AMENDMENTS TO THE DRAWINGS

REMARKS

Objections to the Drawings

Fig. 1

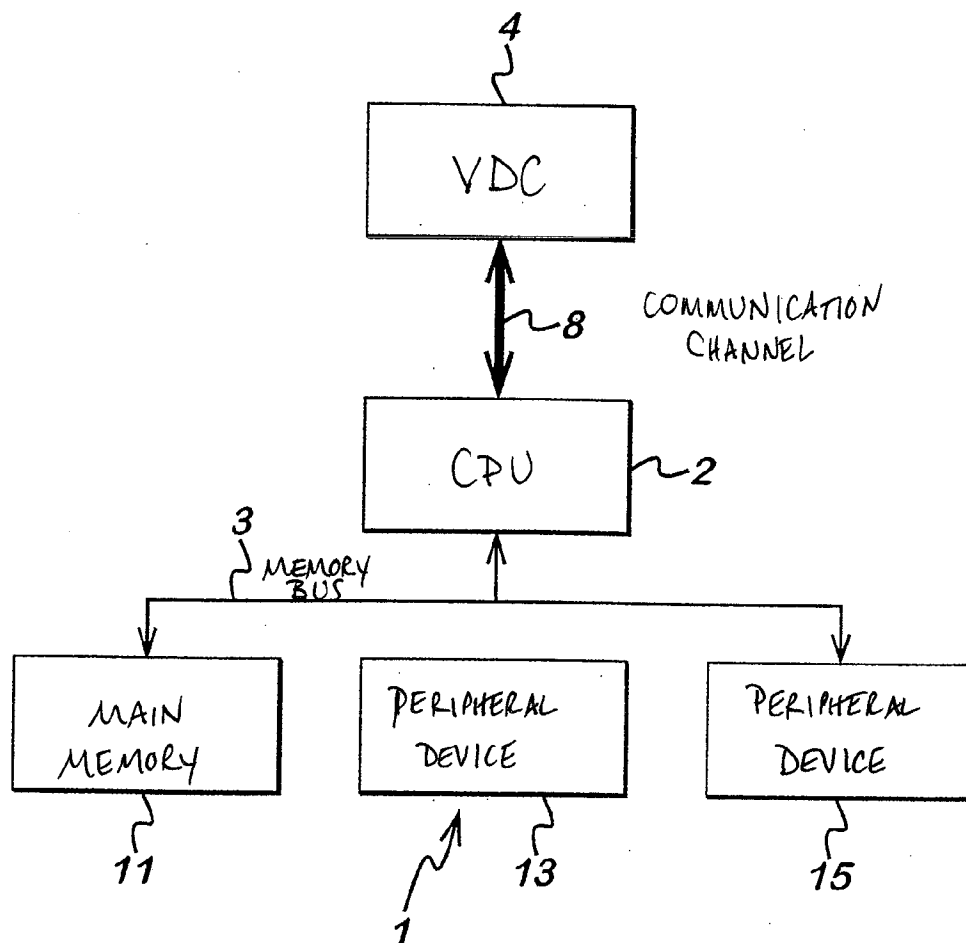
The Office Action objected to the drawings under 37 CFR 1.83(a) as allegedly failing to show any functional description. Applicants have herein amended Figs. 1-5 to address the Examiner's concerns.

“Annotated Sheets Showing Changes” are attached which include marked-up versions of Figures 1-5.
